# Service Letter

**SL:** 5239  
**Date:** 6 November 2008  
**Product:** Loader  
**Subject:** Improvements to First Generation Joystick Control

Figure 1

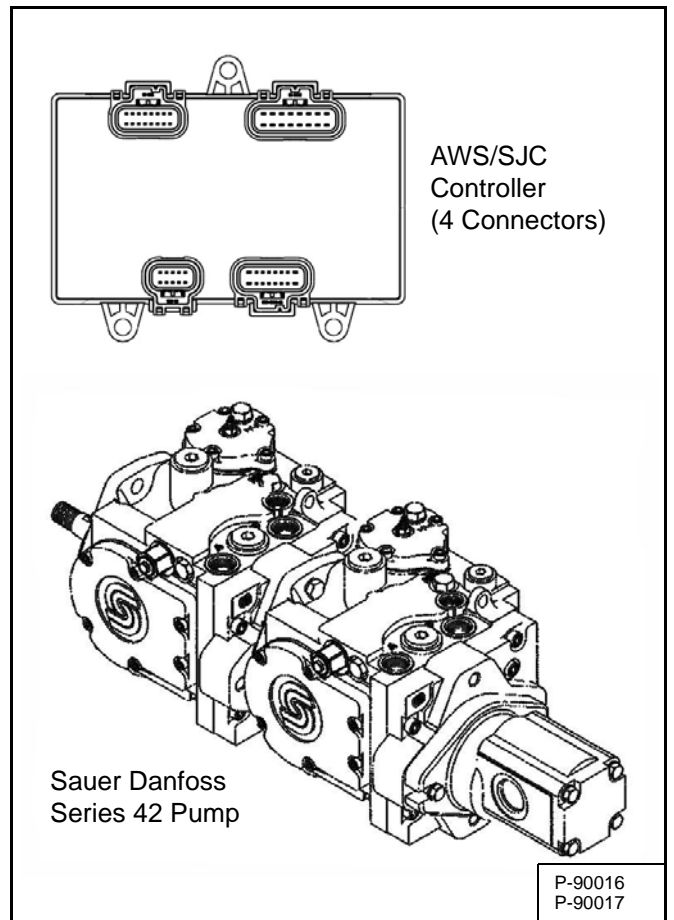
**[Figure 1]** First generation AWS and SJC design uses an “AWS/SJC Controller” and a Sauer Danfoss Series 42 hydrostatic pump. This is another way to identify a first generation loader.
